**DIVISION OF RATEPAYER ADVOCATES  
CALIFORNIA PUBLIC UTILITIES COMMISSION**

**DRA REPORT ON THE  
PIPELINE SAFETY ENHANCEMENT PLAN OF  
PACIFIC GAS AND ELECTRIC COMPANY**

Implementation Plan Analysis and Recommendations

San Francisco, California  
January 31, 2012

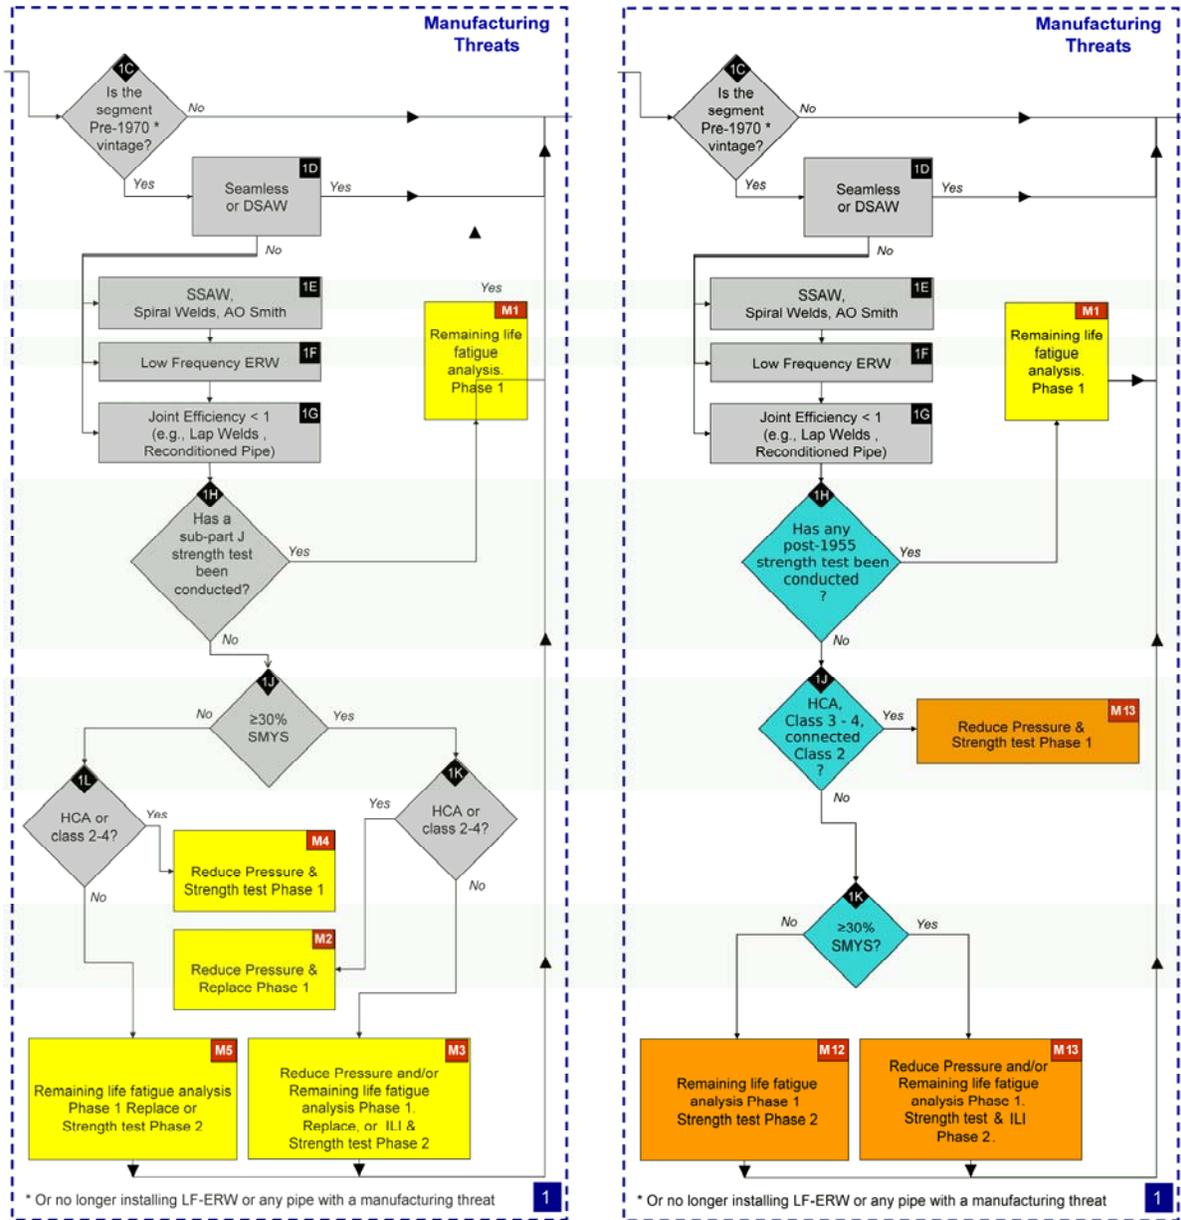
8 Subpart J testing was incorrectly used to evaluate potential pipe joint fabrication  
9 threats. Because documentation of a Subpart J test should not be a deciding point for  
10 taking action on a fabrication or construction threat, BEAR recommends to remove  
11 Subpart J testing as a decision criteria from the Fabrication and Construction portion, part  
12 2, portion of the Decision Tree.

Figure 1a: Decision Tree Comparison – Manufacturing Threats

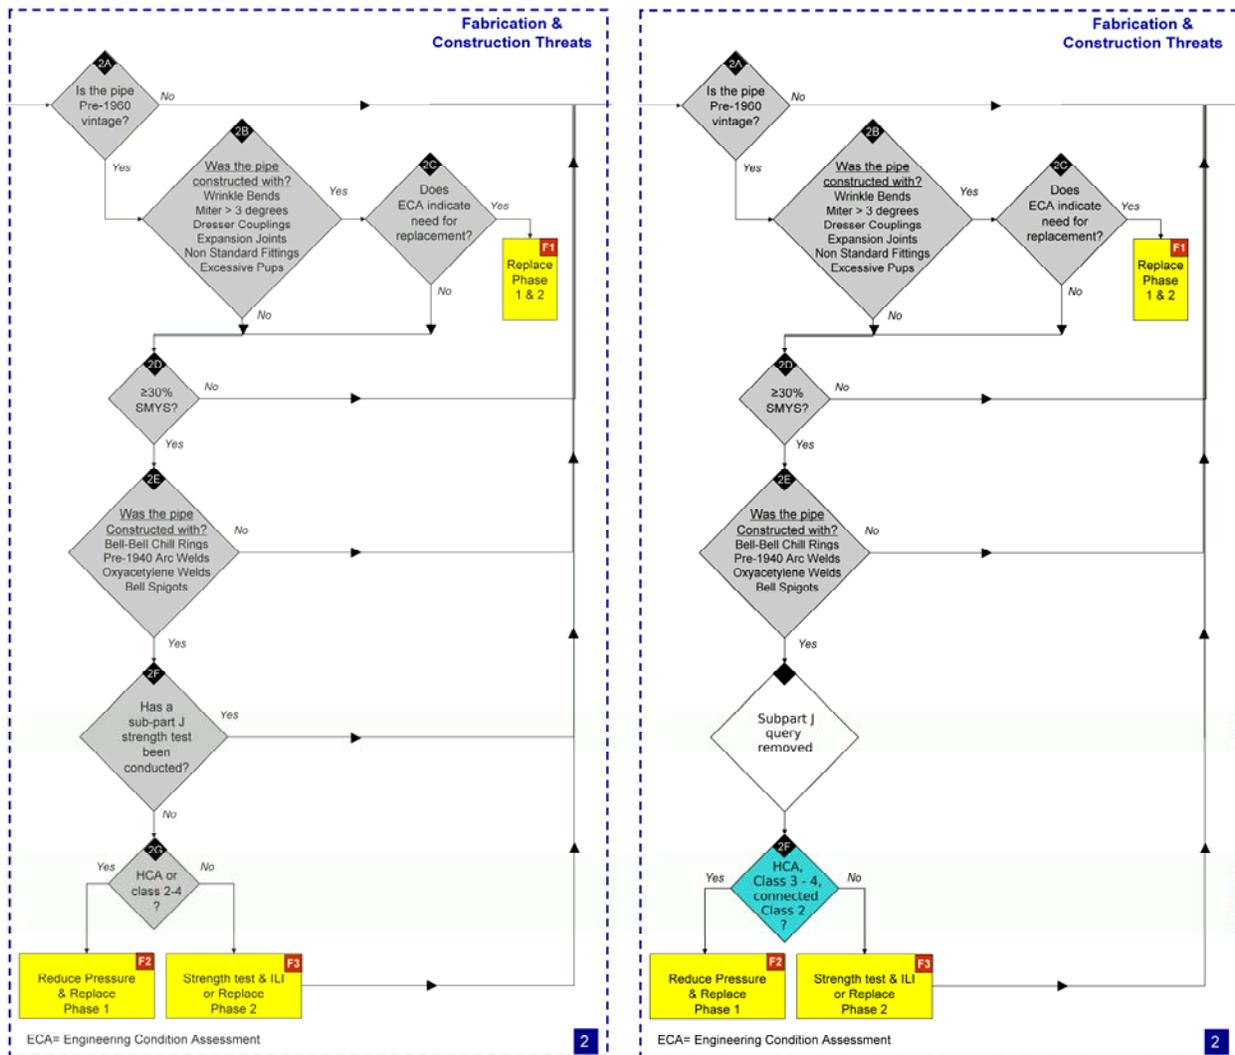
13 BEAR recommends that, with the exception of fabrication and construction threats  
14 (joints between segments), the first action to mitigate risk should be a Subpart J test, in-  
15 line inspection (ILI), and/or a remaining life fatigue analysis.

2           In addition to the above classification prioritization, additional improvement in  
3 Phase 1 prioritization comes from two other modifications within the Manufacturing  
4 Threats branch. First is a greater reliance on fatigue analysis and second is using a wider  
5 range of strength tests as input into the fatigue analysis.

6           Rather than query whether a Subpart J test has been conducted (at 1H,  
7 Manufacturing Threats), the query should include any post-1955 strength test, which was  
8 when the ASA B31.1.8 standard included test pressures based on population density. The  
9 strength test results and pressure history can be put to immediate use in a fatigue analysis,  
10 the results of which would guide further action. By doing so, Phase 1 strength testing  
11 will focus on pipes with almost a completely unknown potential for flaw size. Phase 2  
12 will address updating all tests to Subpart J standards.

13           In addition, it should also be noted that replacement as a default Phase 1 action has  
14 been removed from the Manufacturing Threats branch. Replacement may still occur as  
15 the result of a strength test, fatigue analysis, or a Phase 2 decision. With these  
16 modifications, manufacturing threats will lead to a Phase 1 strength test if the pipe  
17 segment has no post-1955 test results and is in a HCA, Class 3-4, or connected Class 2  
18 area.
